Re: Cost Change Proposal Number 3, 57831683-22 Cathodic Protection Program FY22

Change of Contract Price Proposal No.3

Cathodic Protection Program FY22

Pipe Depth Impact

Fig 1: Benching Requirements per OSHA 1926 Subpart p App B Sloping and Benching, Excavations made in Type B Soil

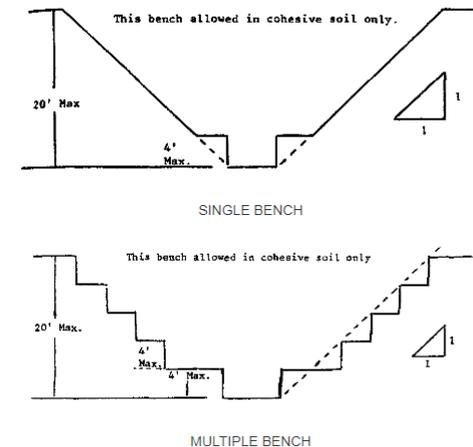
Requirements for benching size and spacing are determined by soil type; these excavations have been in type B soils, requiring a 1:1 height to width ratio (*Figure 1*).

Figure 2: Soil Volumes Removed at Depth

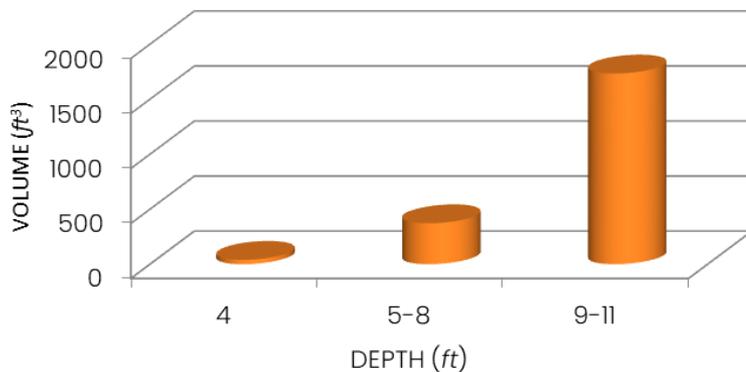
To meet OSHA standard 1926 Subpart P, benching has been utilized to safely excavate water main exceeding five feet in depth. An excavation at 5-8ft requires moving more than 9 times more dirt than an excavation at 4ft (*Figure 2*). This has continued to quadruple labor hours to install a single galvanic anode (*Figure 3*).

Figure 3: Hours Required in Relation to Pipe Depth

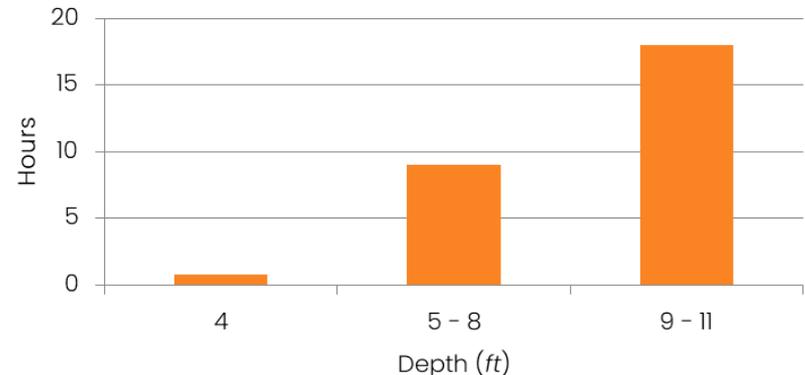
Labor times are significantly increased when excavating deeper than 5ft to meet OSHA requirements. When the pipe is at a 4ft depth, total installation times have taken approximately one hour; depths exceeding 6ft have more than quadrupled installation time, and once depths exceed 8ft, an additional laborer has been necessary to assist with tools and safety.

Figure 4: Surface Area Impact Visualization

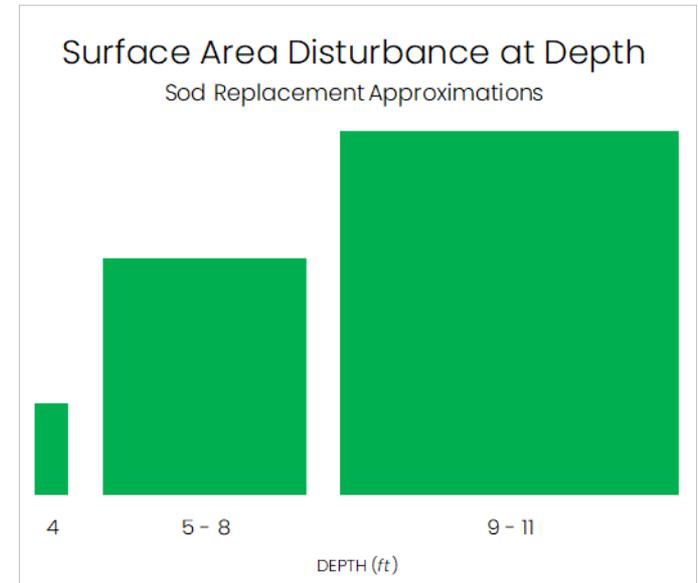
With increased depths, the size of the impacted surface increases considerably. A single pallet of sod typically covers more than 35 excavations of four feet; whereas, that entire pallet of sod is needed to complete a single excavation of nine feet or deeper (*Figure 4*). A recent clean-up of a seven foot excavation required an entire pallet of sod and 12 labor hours to complete; this site has required over 1,500 gallons of water and four labor hours weekly to maintain.
